MIAMI BEACH

Staff Report & Recommendation

Design Review Board

SUBJECT: DRB20-0562
416 West San Marino Drive

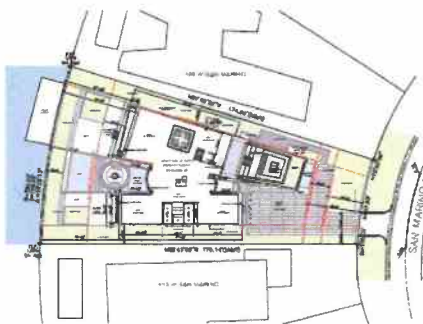
The applicant is requesting Design Review Approval for the construction of a new two-story residence on a vacant waterfront parcel on the northern tip of San Marino Island. The proposal includes a request for four design waivers, as well as the review of the location of the elevator. The design floor elevation of the new residence is proposed at base flood elevation (9') plus maximum free board +1' or +10.00' NGVD.

The waterfront parcel is pie-shaped and the massing of the home conforms to the site as two coplanar bar buildings that are unified by a central elliptical volume. The home features end walls that angle upward and out creating apertures at the ends of the bars facing the bay and the street. The design contrasts these robust travertine walls with bronze glazing bronze metal projecting volumes. The staunch design is softened with a water feature on the front facade that cascades to the ground as a concave vertical slope, as well as by the two-story central volume that protrudes on the front and rear facades as glazing. The south and rear facing elevations have a much lighter presence with the incorporation of floor to ceiling fenestration.
